U. S. Nuclear Regulatory Commission
ATTN: Document Control Desk
Washington, DC 20555Calvert Cliffs Nuclear Power Plant, Unit Nos. 1 and 2
Renewed Facility Operating License Nos. DPR-53 and DPR-69
NRC Docket Nos. 50-317 and 50-318Independent Spent Fuel Storage Installation
License No. SNM-2505
NRC Docket No. 72-8

Subject: Request for Supplemental Information – Amendment Request No. 11 to
Materials License No. SNM-2505 for the Calvert Cliffs Specific Independent
Spent Fuel Storage Installation – Acceptance Review

REQUEST FOR SUPPLEMENTAL INFORMATION

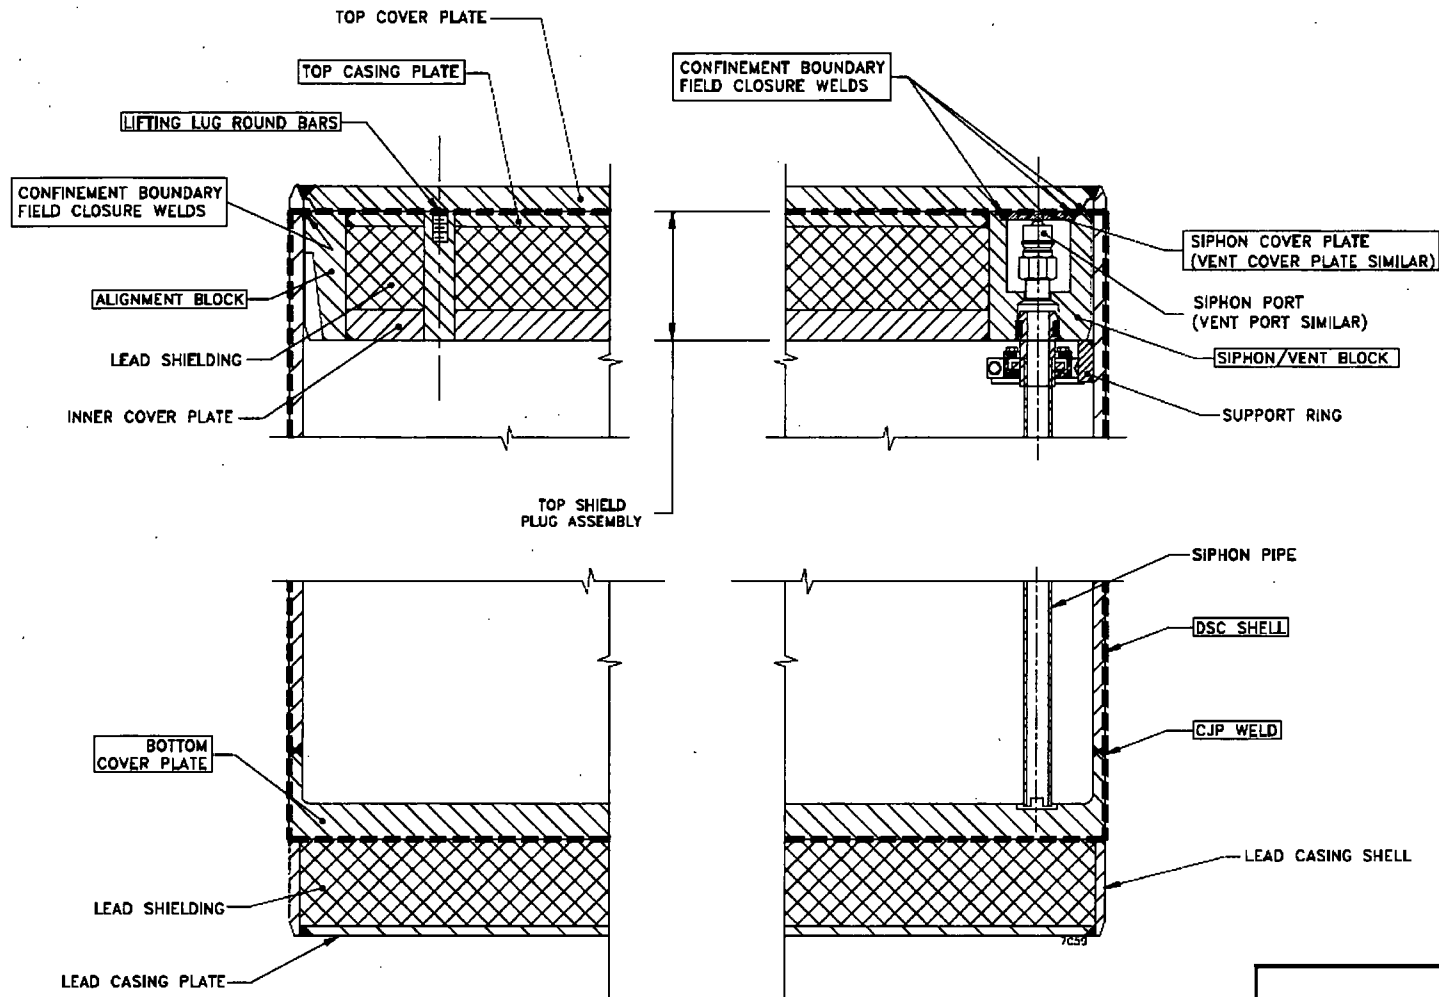
- a) *Per Section 9.5.1 of NUREG-1567, details of the confinement boundary should be provided, including a clear drawing and description of the entire confinement boundary. In addition, drawings or sketches defining "top shield plug closure weld" (page 5), "top cover plate weld" (page 5), and "double seal welded primary and secondary closures" at the top and bottom ends of the DSC (page 5 and 13.3-8) would aid in understanding the confinement boundary.*
- b) *Note 1 in Drawing NUH32PHB-30-20 indicates the presence of an O-ring. The details of the O-ring groove and O-ring, including its purpose, should be provided. In addition, specify if there are O-ring degradation issues over the license period.*

The physical design of the confinement boundary for the NUHOMS-32PHB DSC is identical to that of the NUHOMS-32P DSC currently licensed for use at Calvert Cliffs ISFSI. The confinement boundary components are called out in Transnuclear drawings NUH32PHB-30-1 and NUH32PHB-30-4 as follows:

- 1. Item 52: Siphon/Vent block (component of top shield plug assembly Item 50)
- 3. Item 53: Alignment block (component of top shield plug assembly Item 50)
- 4. Item 54: Top casing plate (component of top shield plug assembly Item 50)
- 5. Item 58: Lifting lug round bars (component of top shield plug assembly Item 50)
- 6. Item 2: DSC Shell
- 7. Item 10: Bottom cover plate

The associated shop and field welds between the above components are also part of the confinement boundary and are constructed to meet the American Society of Mechanical Engineers Section III, Subsection NB requirements. A sketch is provided below summarizing the above discussion.

The O-Rings identified as item 20 on Note 1 of Transnuclear drawing NUH32PHB-30-20 can be seen in detail along with the groove in which they are located on Section B-B of Transnuclear drawing NUH32PHB-30-2. They are located on the siphon tube adaptor and their purpose is to provide a seal between the adapter and the siphon block on the top shield plug to support blowdown of the DSC. They are not part of the confinement boundary, are classified as not important to safety and as indicated on Table 3.3-1 of Attachment (1) of Reference 2, the siphon tube does not have an intended function for license renewal. They are therefore not subject to aging management.
